ADDENDUM No. 1

RFP No. 26-07

Needham, Medford and Buckingham Water Main and Resurfacing

CONSTRUCTION PLAN - MEDFORD RD - STA 25+75 TO STA 29+50

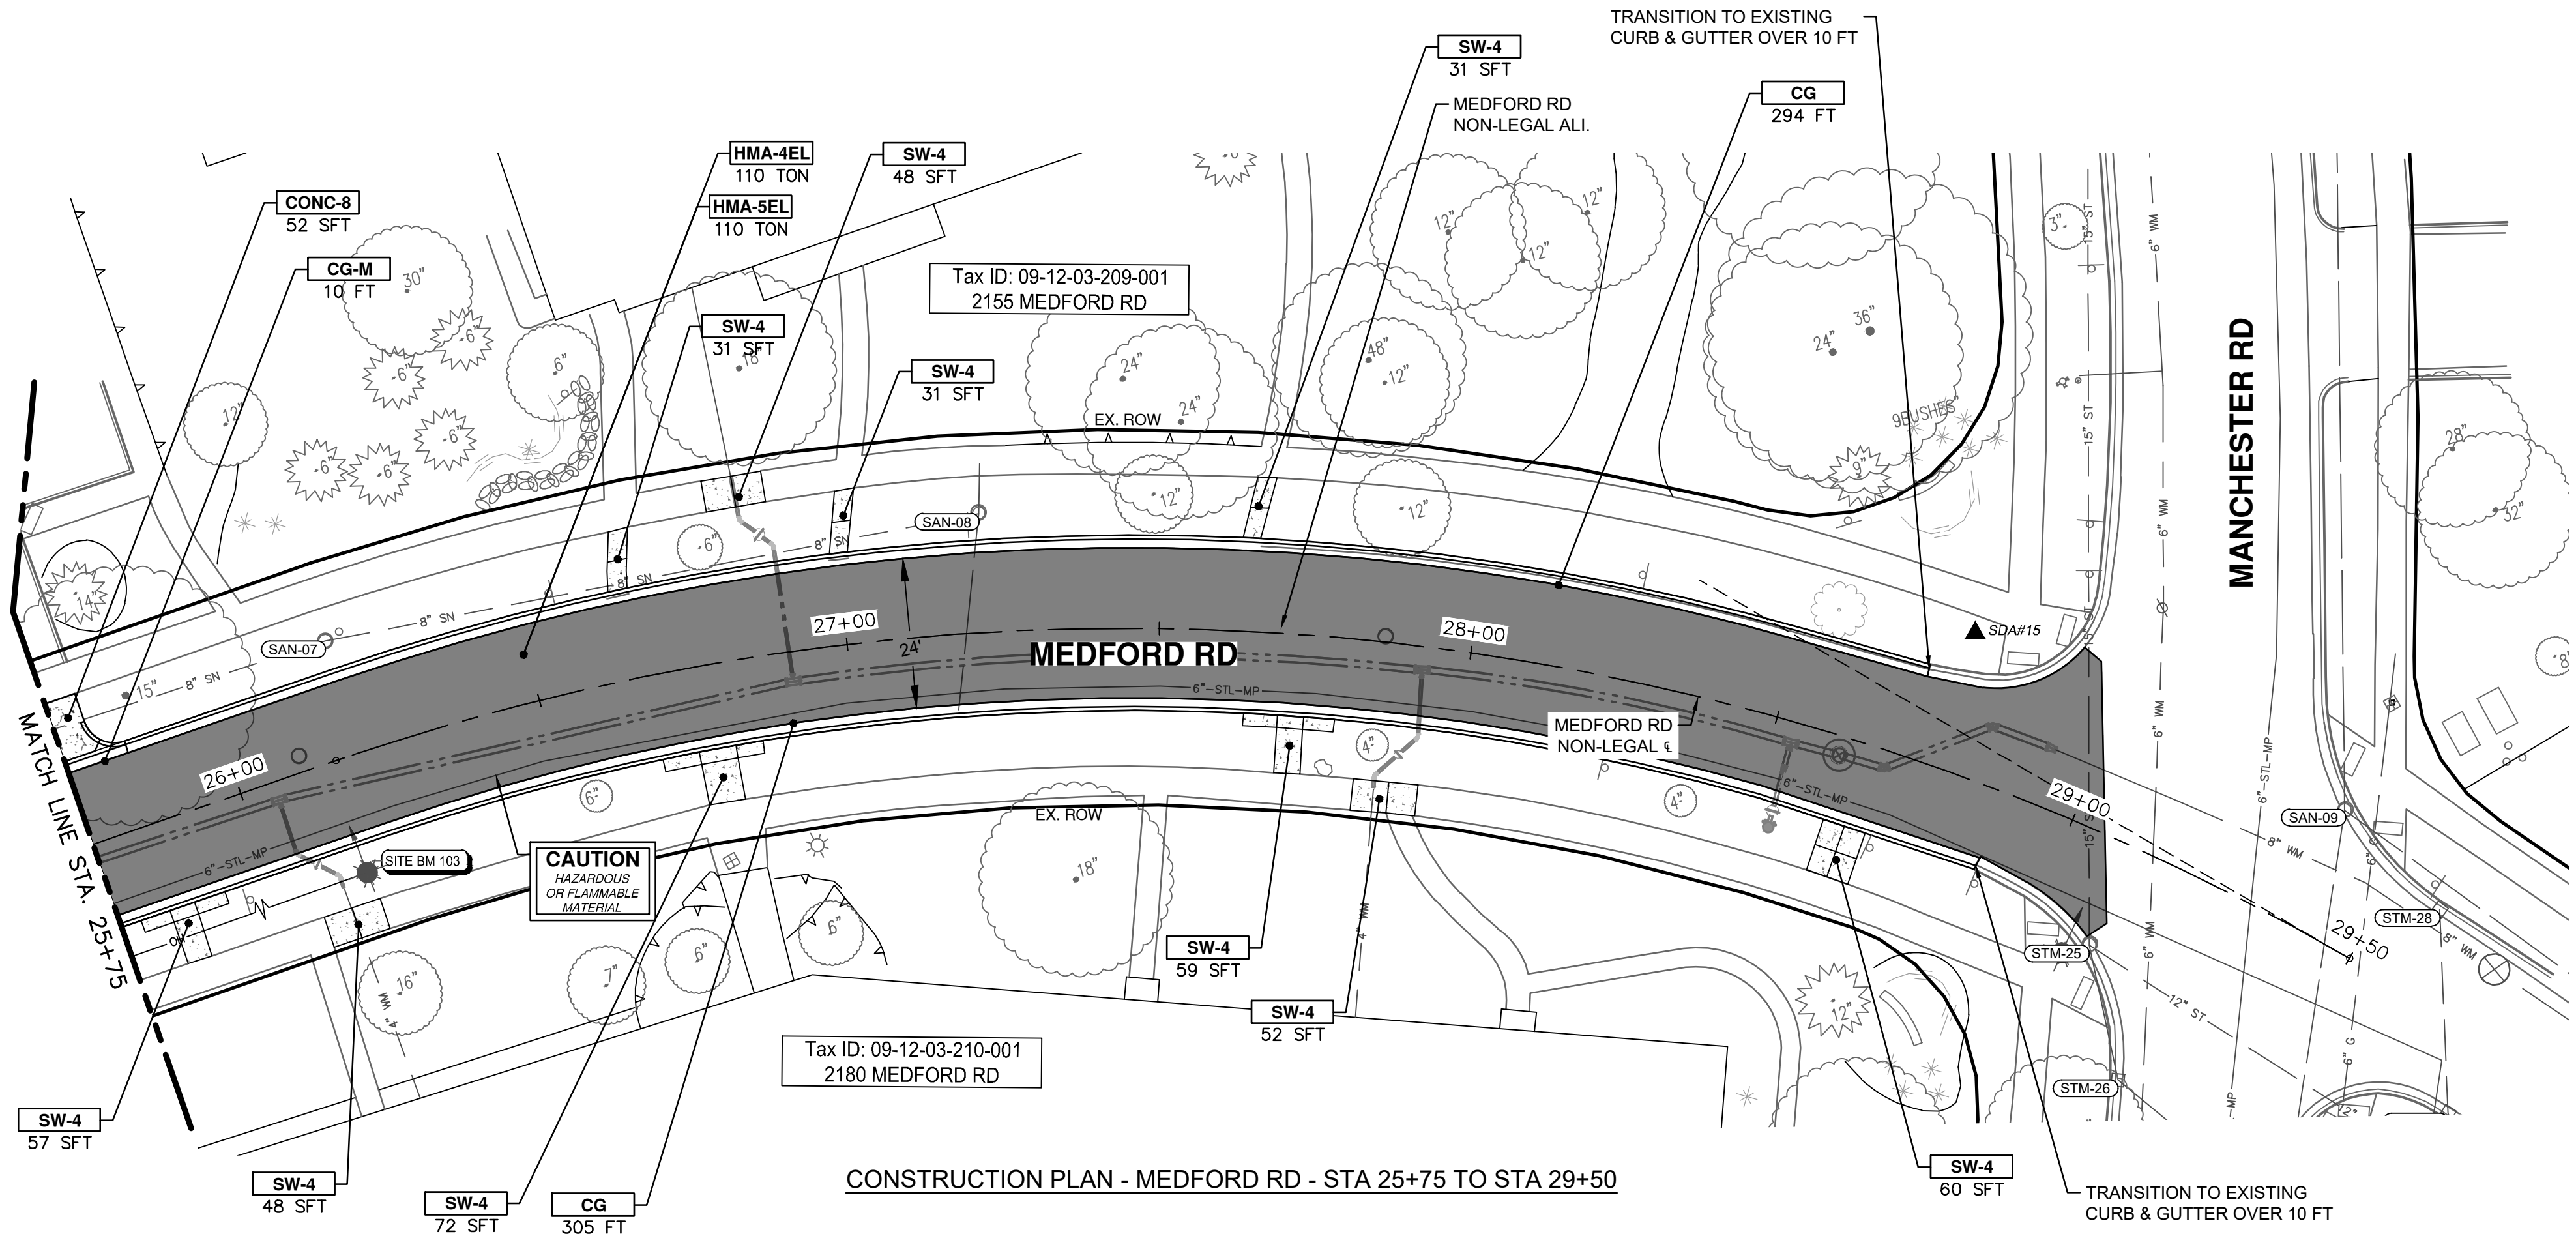
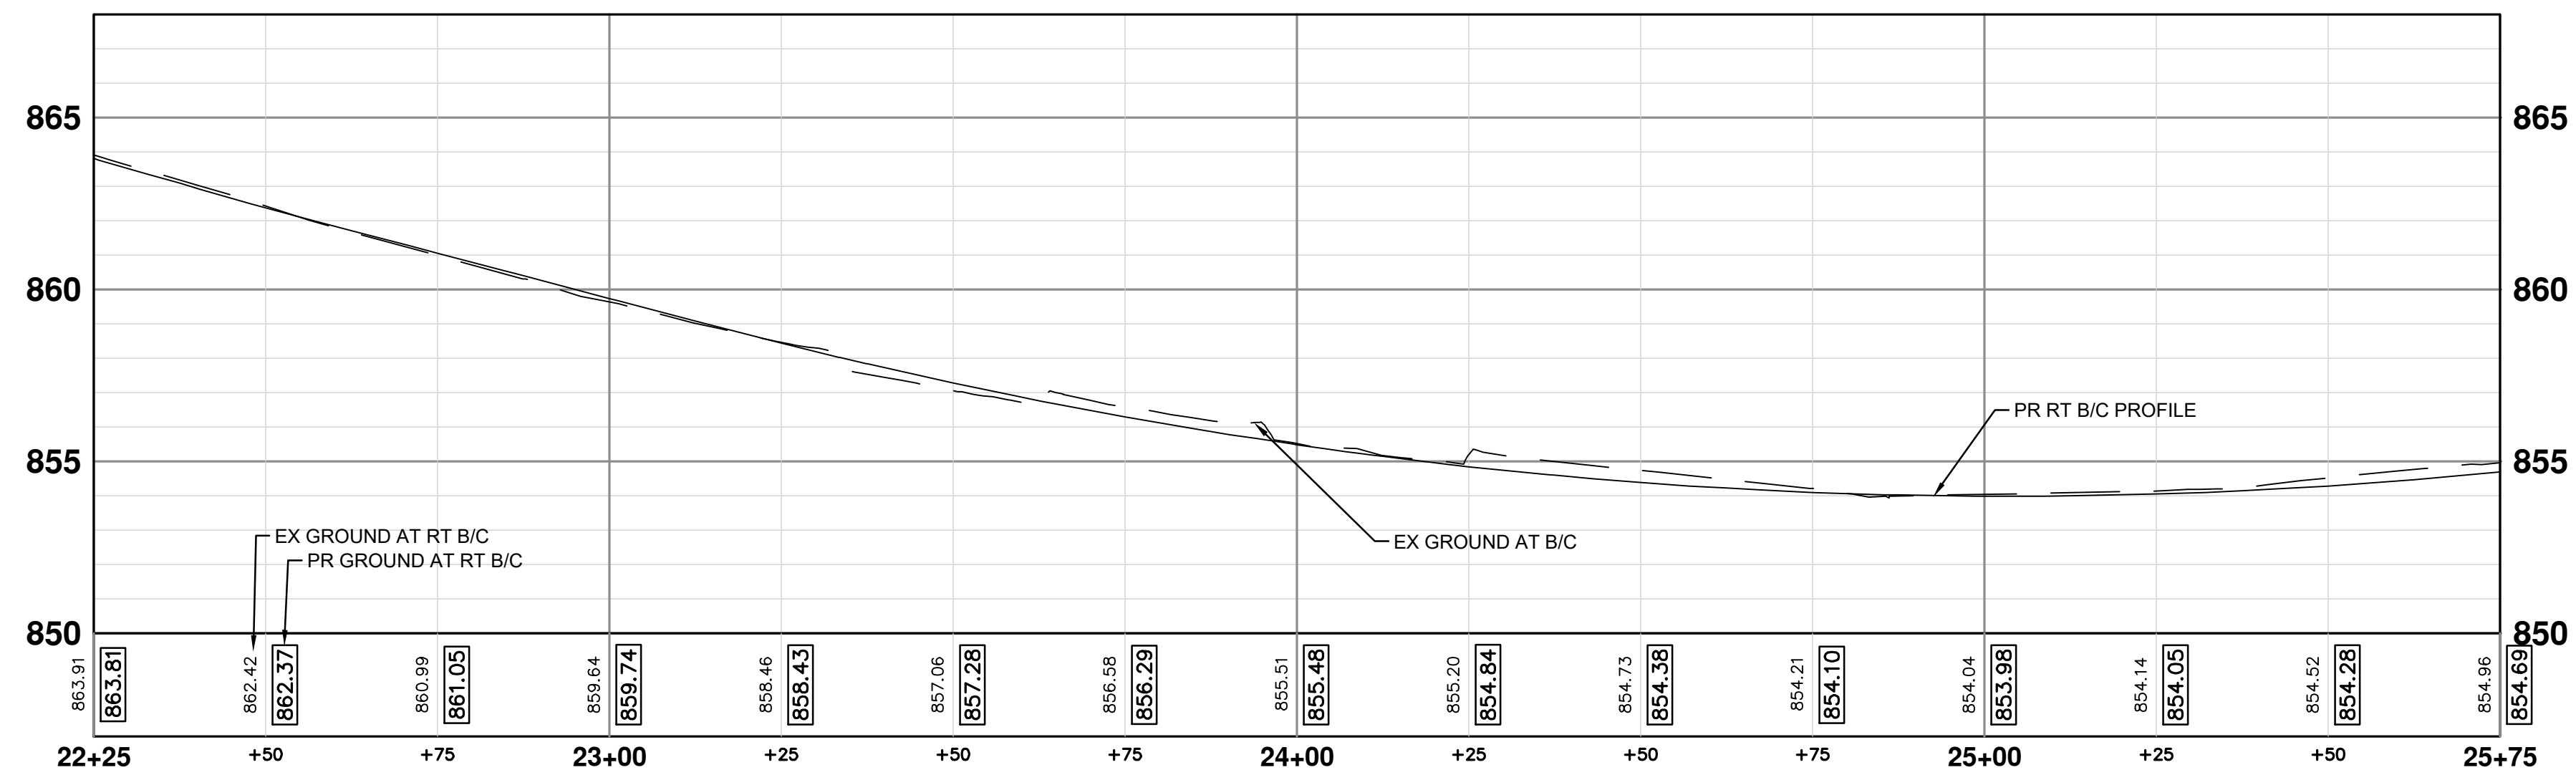
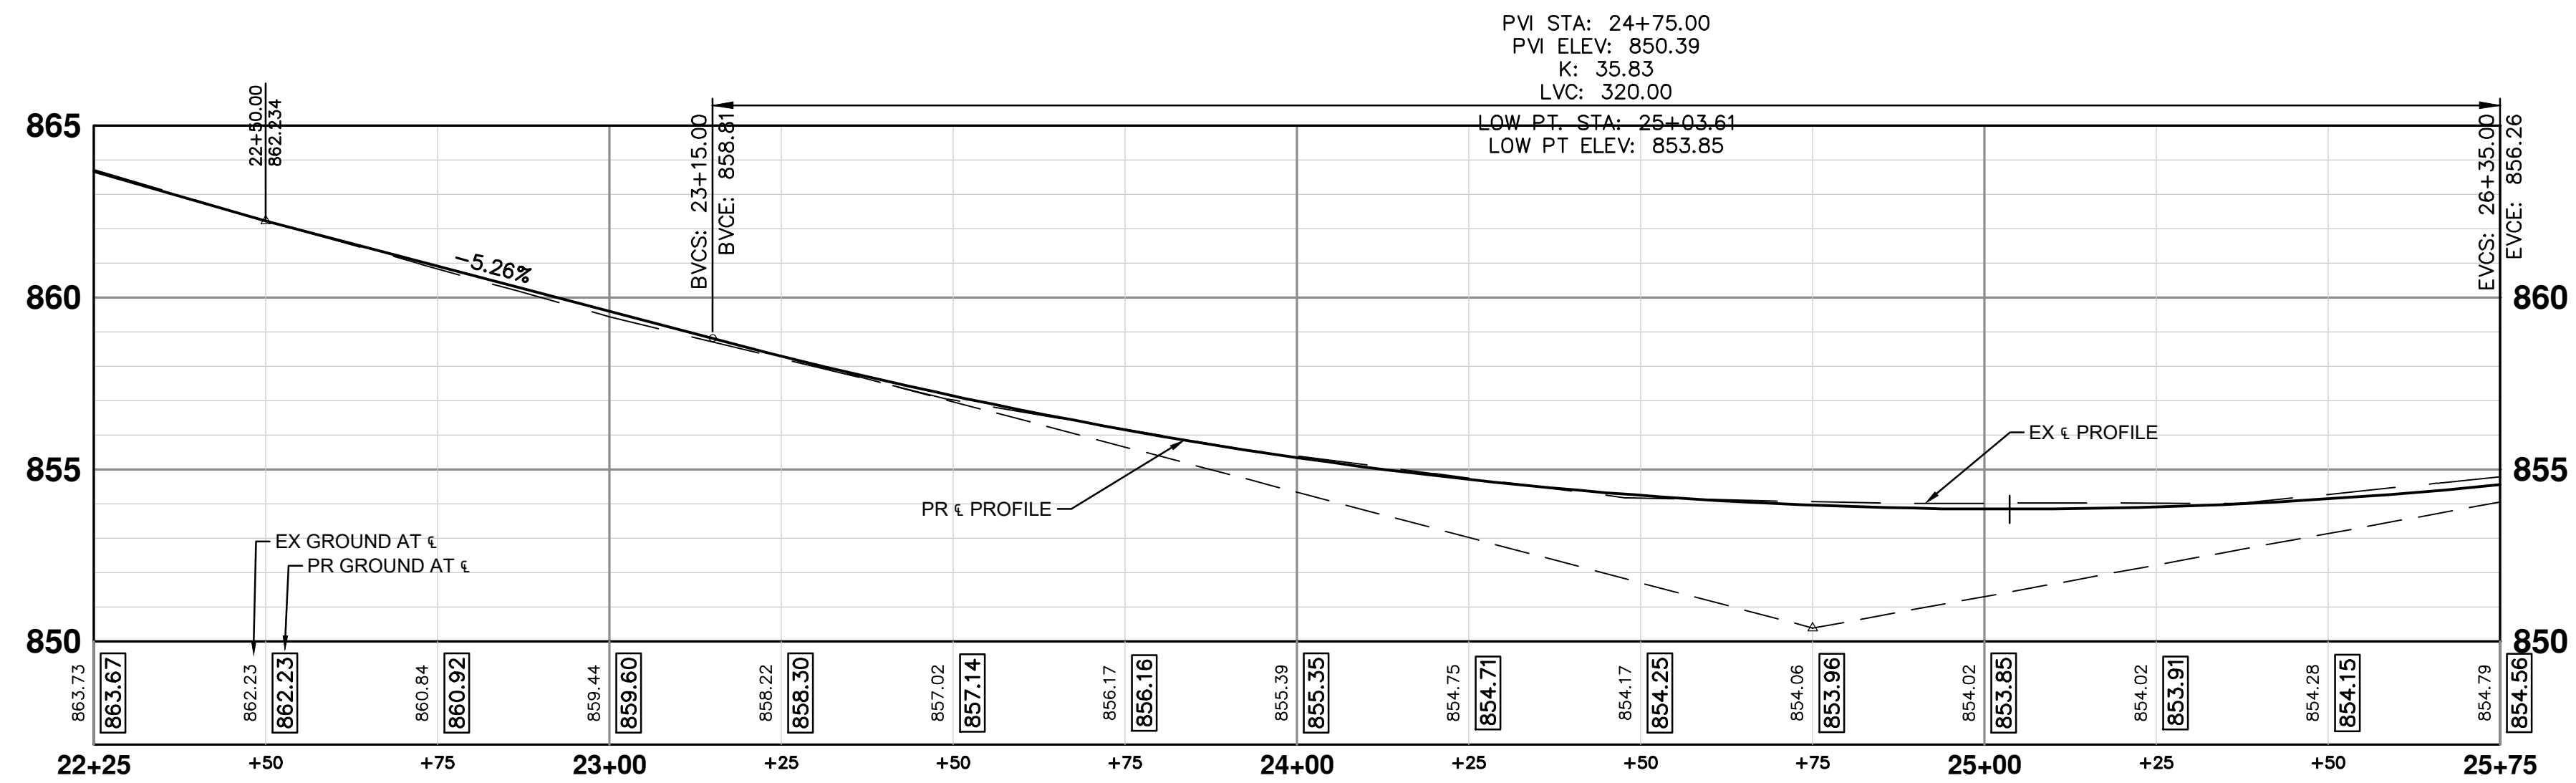
Sheet 2:	1. Added Note #29 - "Six inches of 21AA aggregate base stone to be used at all drive approach replacements" 2. Updated Quantity Table: a. Added Tree, Medium, B&B - 5 EA b. Added Gate Box, Adj - 5 EA
Sheet 15:	Added Tree, Rem, 6 In. - 12 In. - 1 EA
Sheet 16:	Added Tree, Rem, 12 In. - 19 In. - 1 EA
Sheets 19 and 20:	No longer showing tree symbol for the trees that will be removed.
Sheet 22:	Added missing 12 in. X 8 In. DIP Reducer - 1 EA
Sheets 23, 25, 27, 29, and 31:	Removed DS_ Aggregate Base Conditioning item from Quantity Boxes
Sheet 38:	Removed DS_ Aggregate Base Conditioning item from Quantity Box

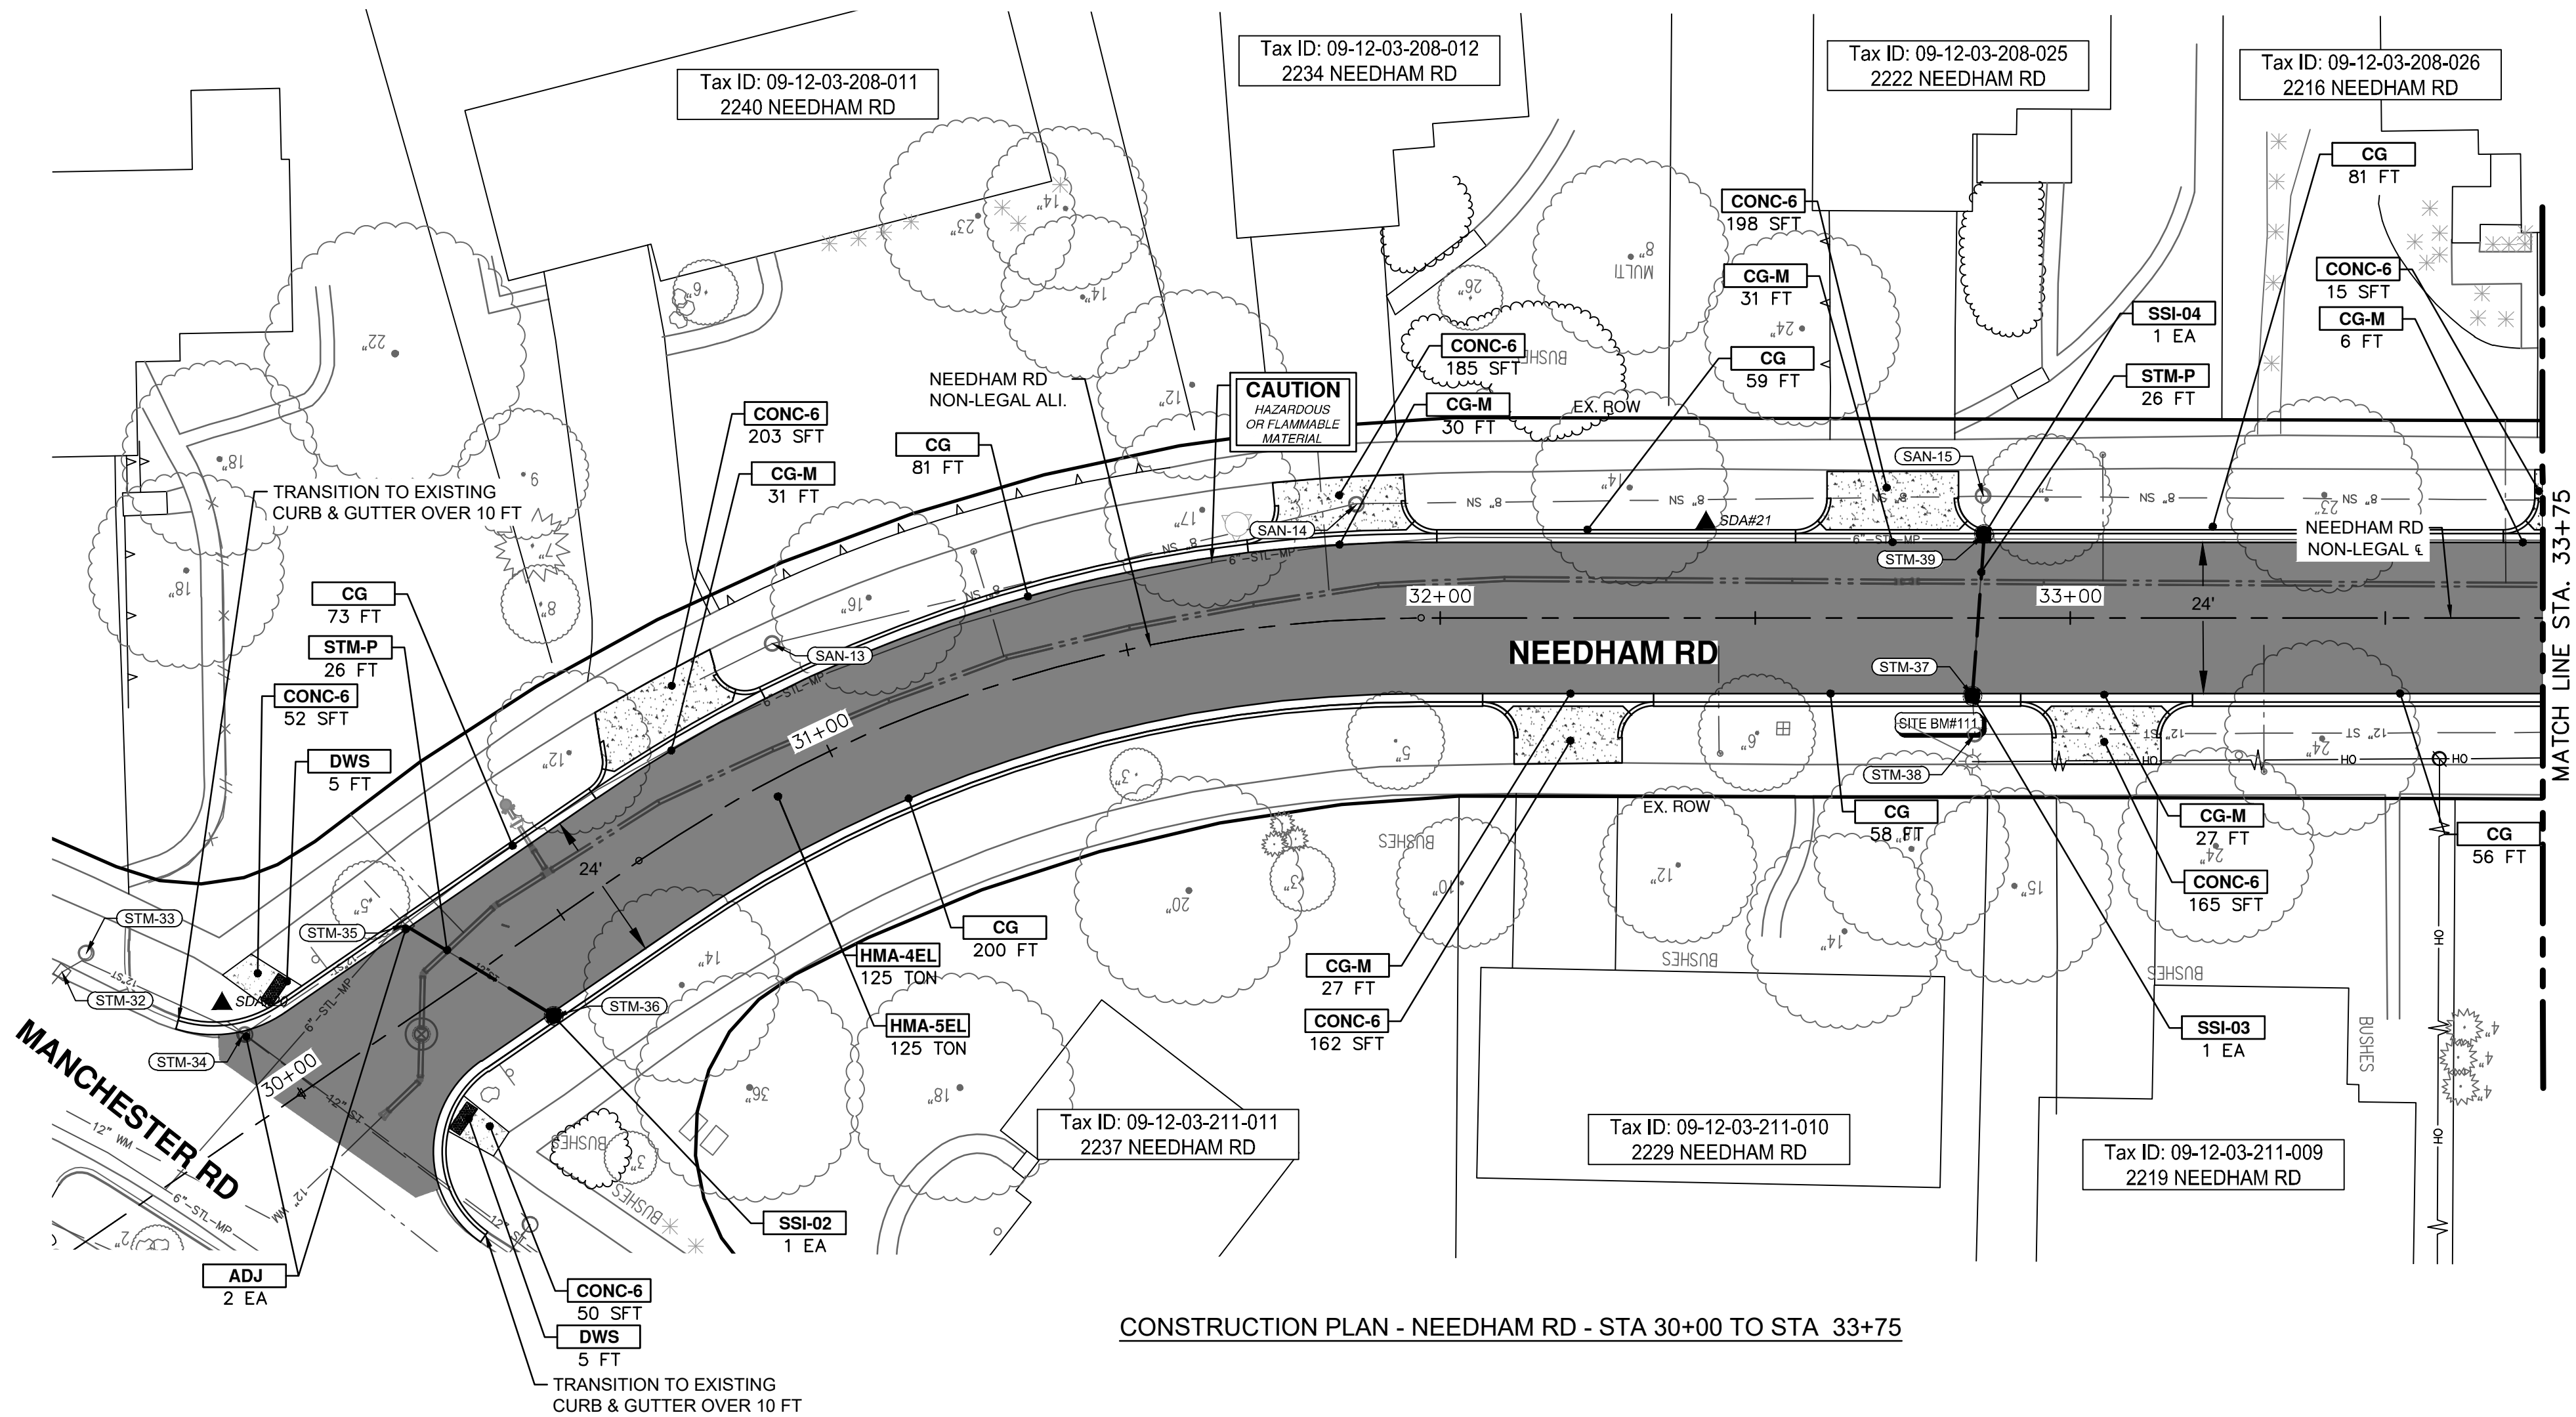
Sheet 40: Added missing quantity (1440 Syd) for Aggregate Base, in.,
21AA CIP to Quantity Box
1. Removed DS_ Aggregate Base Conditioning item from
Quantity Boxes
